Re: Turkey Point Units 3 and 4
Docket Nos. 50-250 and 50-251
Emergency Plan Implementing Procedure Revision

0-EPIP-20126, Offsite Dose Calculations

SUMMMARY OF CHANGES

ATTACHMENT 1
(Page 4 of 7)
METEOROLOGICAL DATA WORKSHEET

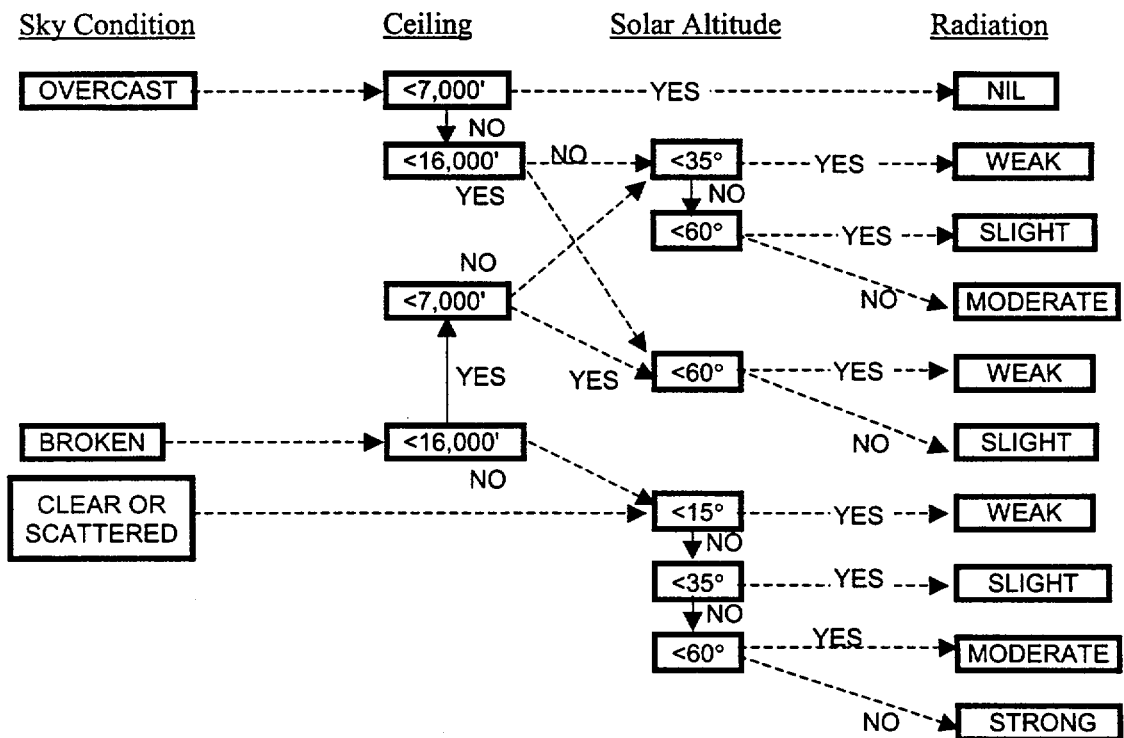
3. Page 20, change made to align procedure to LAN-based rather than stand-alone.
4. Page 24, step added to begin print function.
5. Page 31, Meteorological Data Worksheet, replaced with a better copy.
